Relicensing Study 3.1.2

NORTHFIELD MOUNTAIN/TURNERS FALLS OPERATIONS IMPACT ON EXISTING EROSION AND POTENTIAL BANK INSTABILITY

Initial Study Report Summary

Northfield Mountain Pumped Storage Project (No. 2485)
and Turners Falls Hydroelectric Project (No. 1889)

Service Layer Credits: Sources: Esri, DeLorme, NAVTEQ, USGS, Intermap, iPC, NRCAN, Esri Japan, METI, Esri China (Hong Kong), Esri (Thailand), TomTom, 2013
 Source: Esri, DigitalGlobe, GeoEye, i-cubed, USDA, USGS, AEX, Getmapping, Aerogrid, IGN, IGP, swisstopo, and the GIS User Community

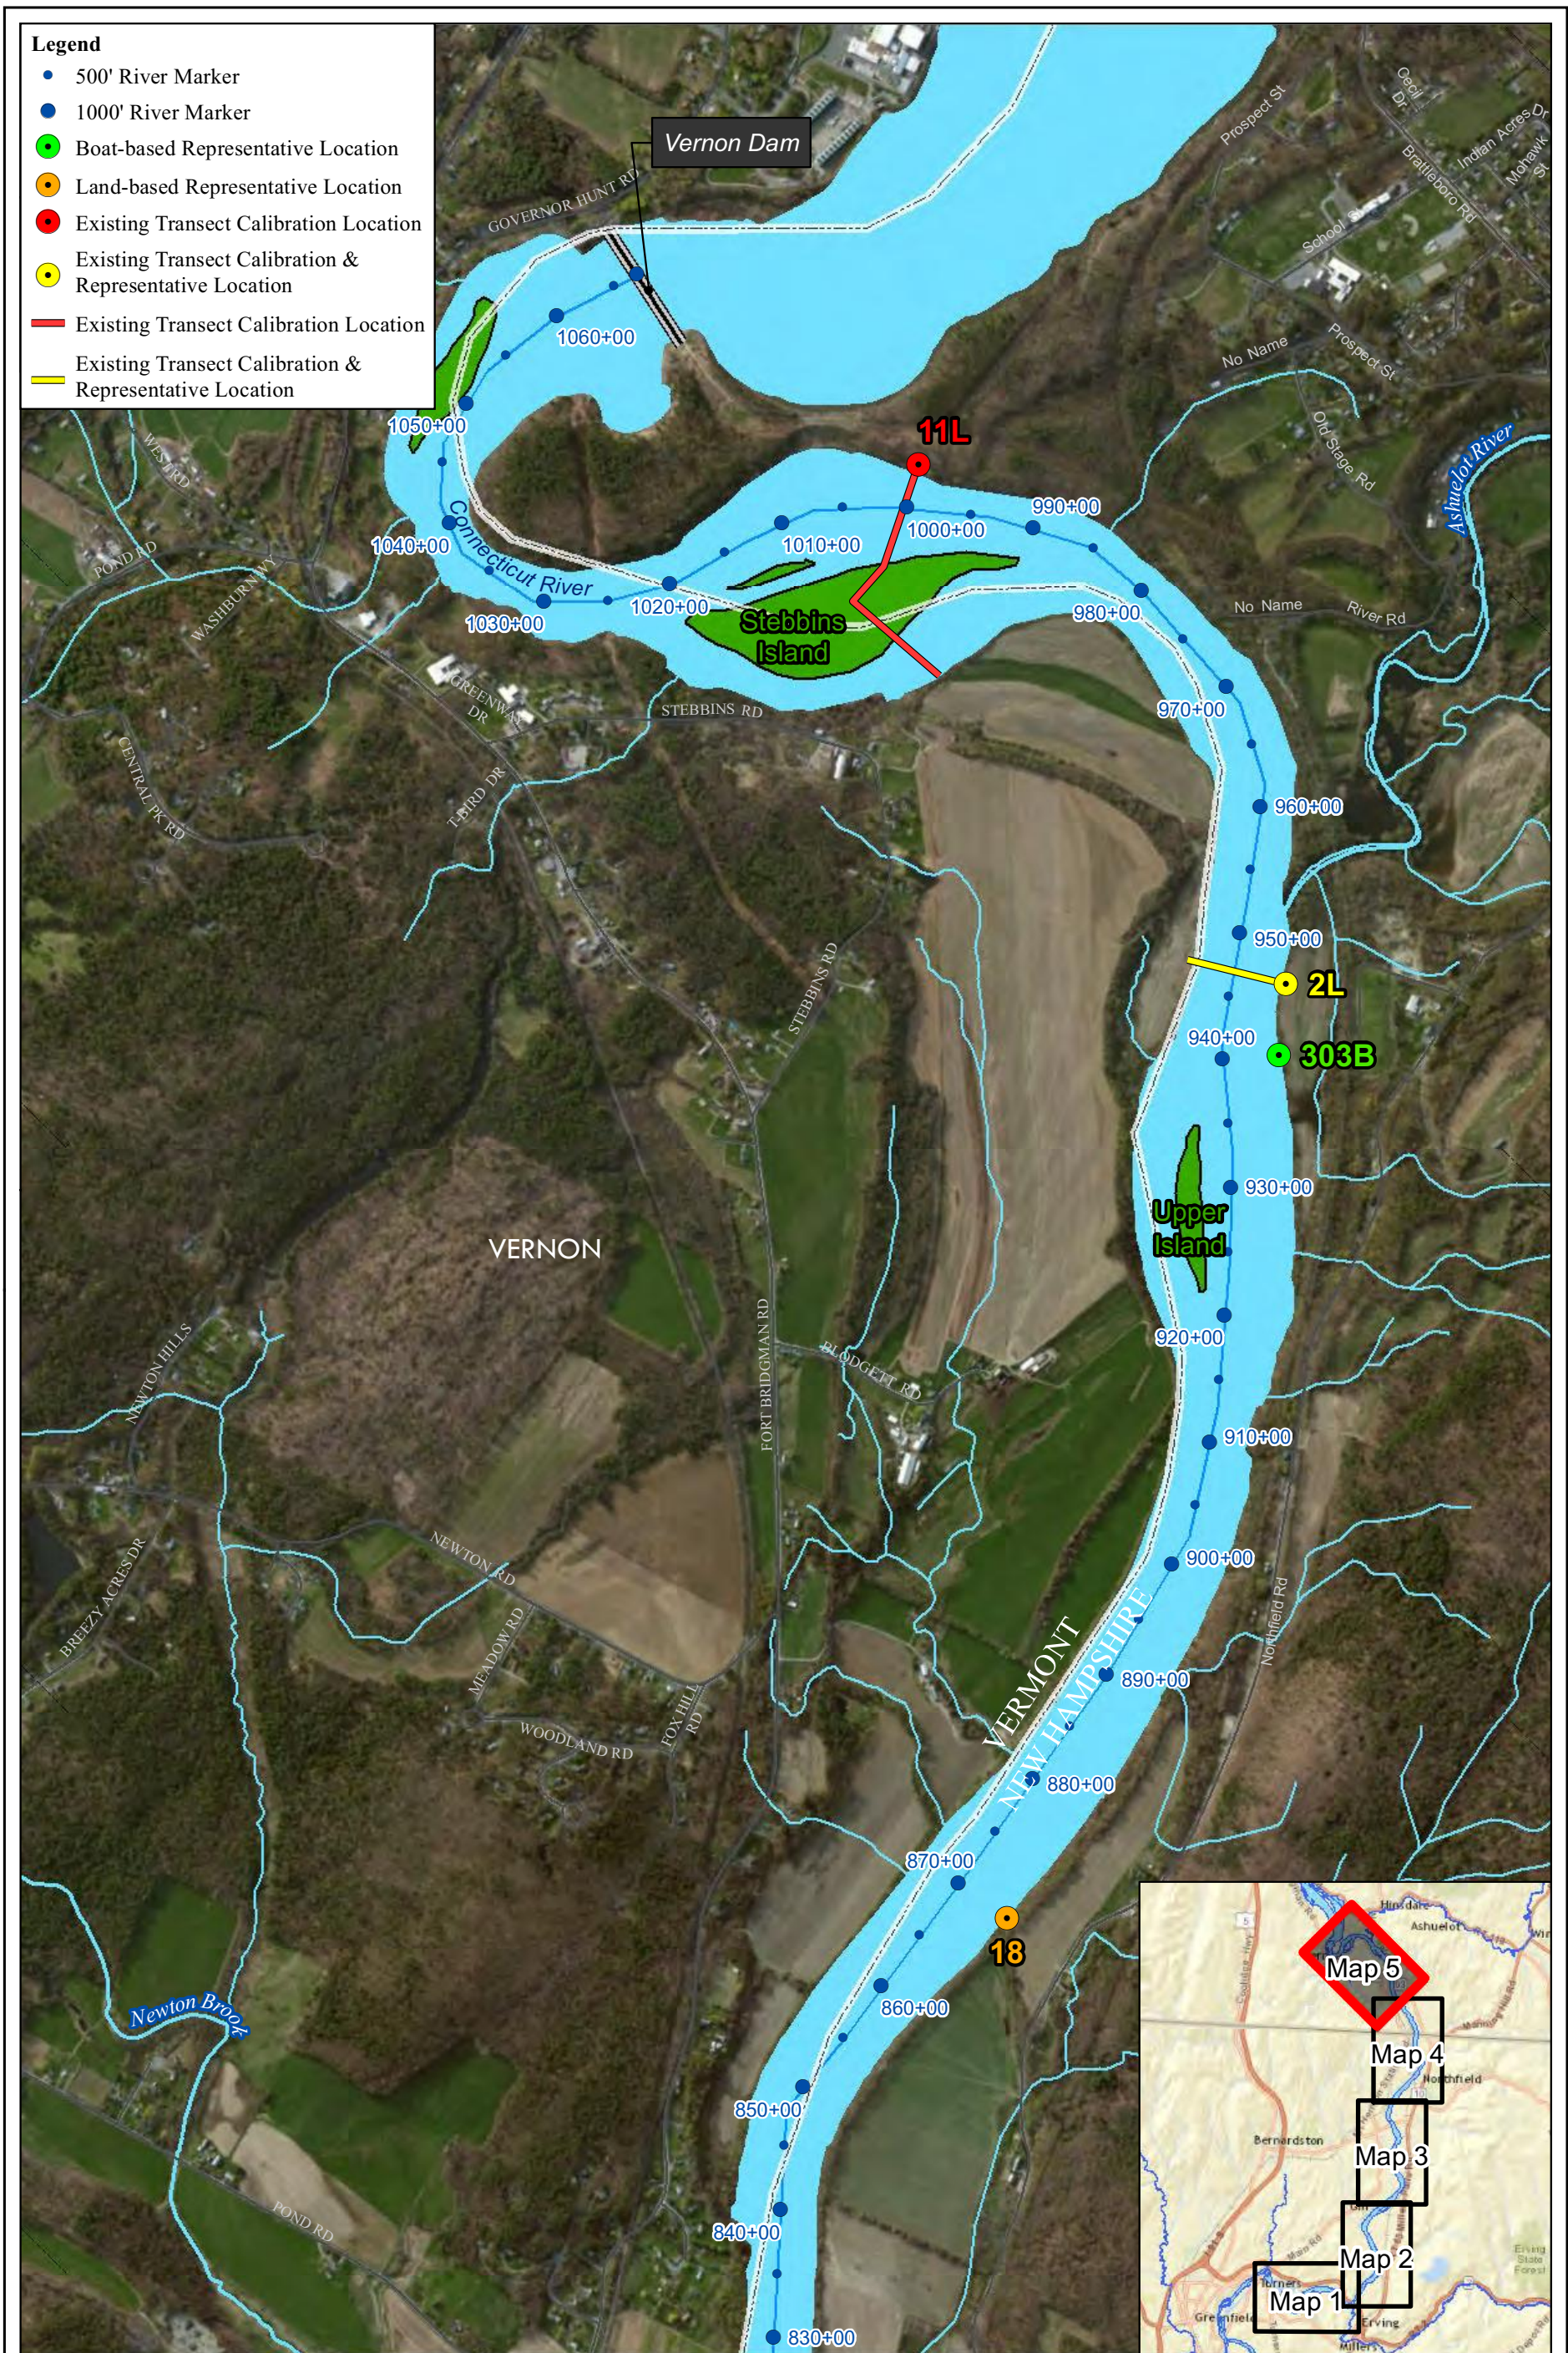
I categorized sites using the Proposed Representative & Calibration Locations for Detailed Study, Figures 7-2 through 7-6 plus one change as presented in Powerpoint at the June 26 meeting.

Comment: The stakeholders compiled a matrix of FirstLight's proposed representative and calibration sites and their locations at an Inside Bend, Outside Bend or Straight Reach. The distribution of these sites should be more even and gaps should be filled. There are plenty of Land-Based Survey locations that could be used to fill these gaps and even the distribution among the morphology types (see last table).

FirstLight has reviewed the letters received to date and has developed the enclosed responsiveness table and associated attachments in response to these comments. Stakeholders raised several concerns about the representativeness of the proposed sites. Concerns were specifically raised in regard to a lack of sites in the vicinity of the Northfield Mountain tailrace and in or near Barton Cove. To address these concerns FirstLight is recommending the addition of sites BC-1R and 87B as well as 303B. Site BC-1R is located on the peninsula entering Barton Cove while Site 87B is located just upstream of the Northfield Mountain tailrace. Site 303B is located downstream of the Ashuelot River confluence and satisfies specific riverbank characteristics requested by the Stakeholders. As explained in the attached documents these

sites will replace Sites 11I, 6A-I, and 90B. More information on this and other Stakeholder concerns can be found in the enclosed documents.
